T ECHNICAL INFORMATION

58886C

- Subject** ▶ Change of O Ring 113
- For Models** ▶ HR5000, HR5000K
- Country** ▶ All countries
- Description** ▶ O Ring 113 has been replaced with Seal Ring for quick repair.

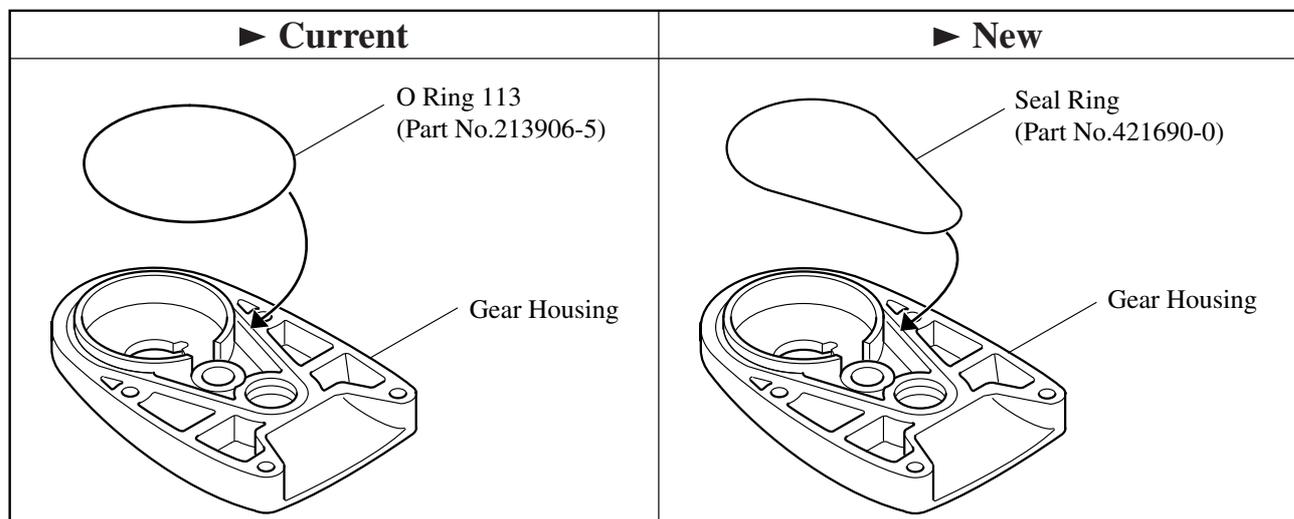
Item No.	Current part		Q'ty	I/C	New part		Q'ty	Note
HR5000; 029 HR5000K; 029	O Ring 113 213906-5		1	Yes	Seal Ring 421690-0		1

HR5000 : From serial No.50947E (July,1999)
 HR5000K : From serial No.56477E (July,1999)
